OTH-PUR-TH-RF-SKE-A-3505

Roof WR27 Lloyd Street tower
Proposed lead capping below
finial

Page 1 of 3
Annotated
photograph

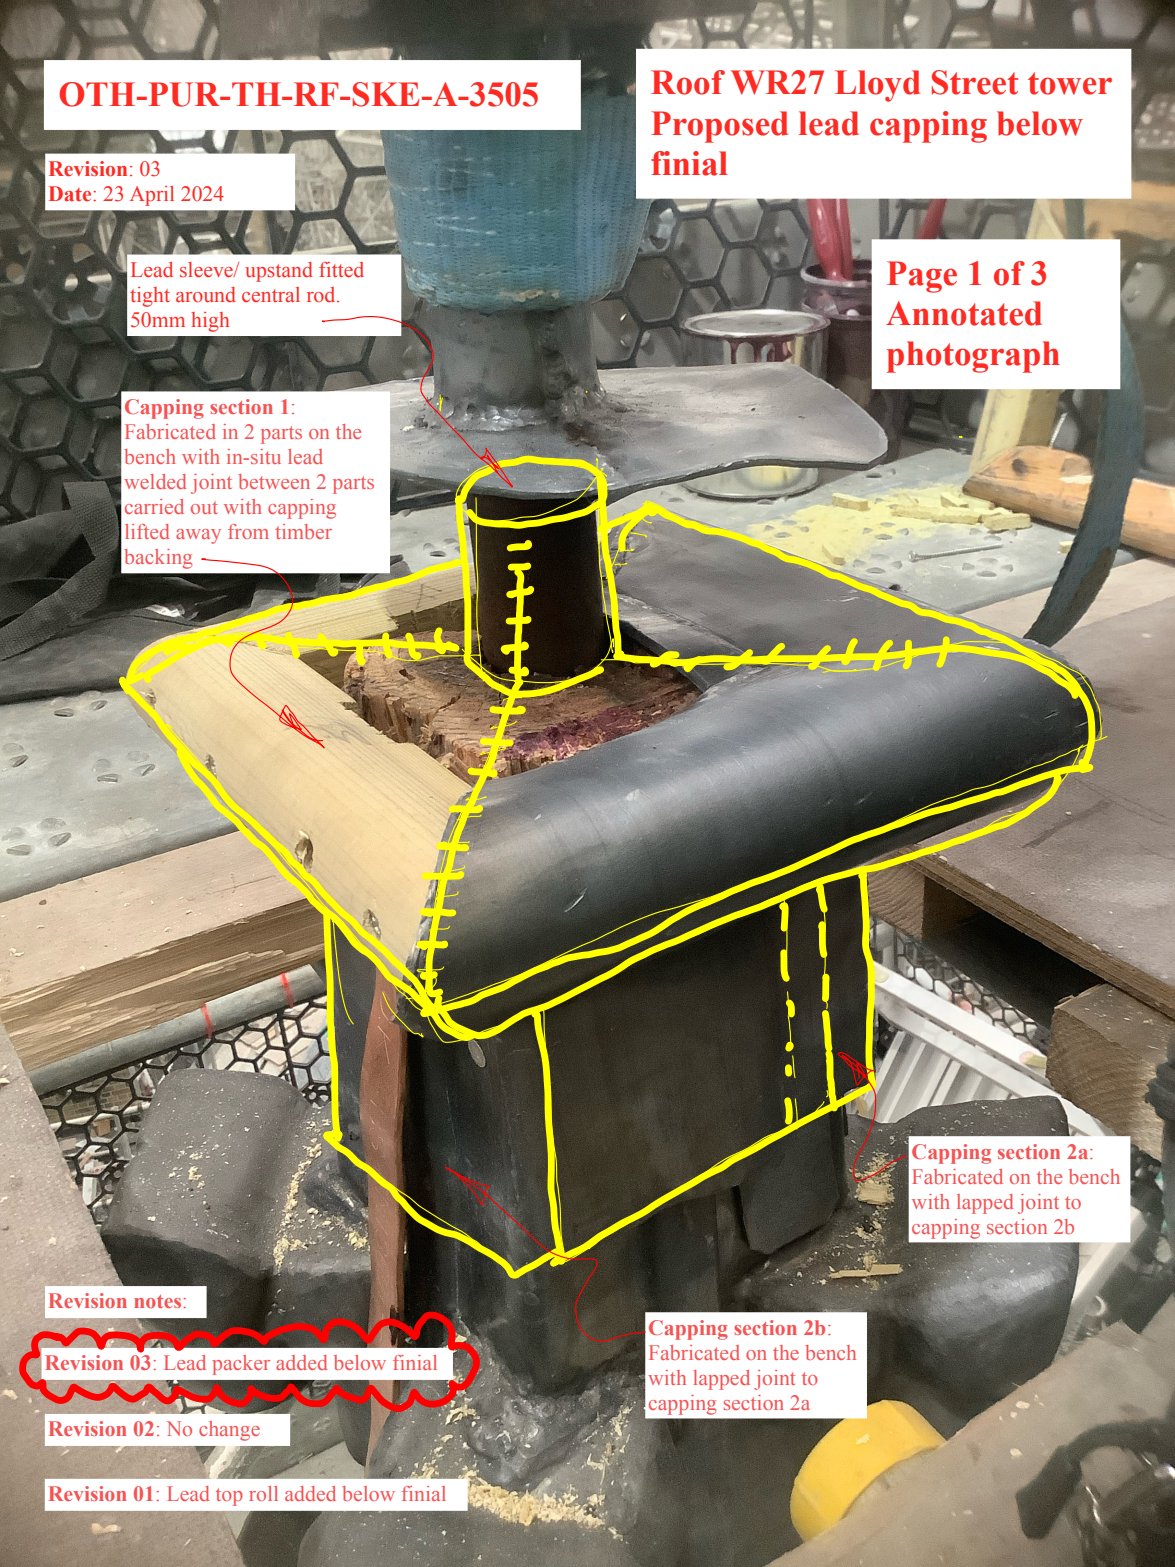
Revision 03: Lead packer added below finial

Revision 01: Lead top roll added below finial

Lead sleeve/ upstand fitted
tight around central rod.
50mm high

Capping section 1:
Fabricated in 2 parts on the
bench with in-situ lead
welded joint between 2 parts
carried out with capping
lifted away from timber
backing

Capping section 2a:
Fabricated on the bench
with lapped joint to
capping section 2b

Capping section 2b:
Fabricated on the bench
with lapped joint to
capping section 2a
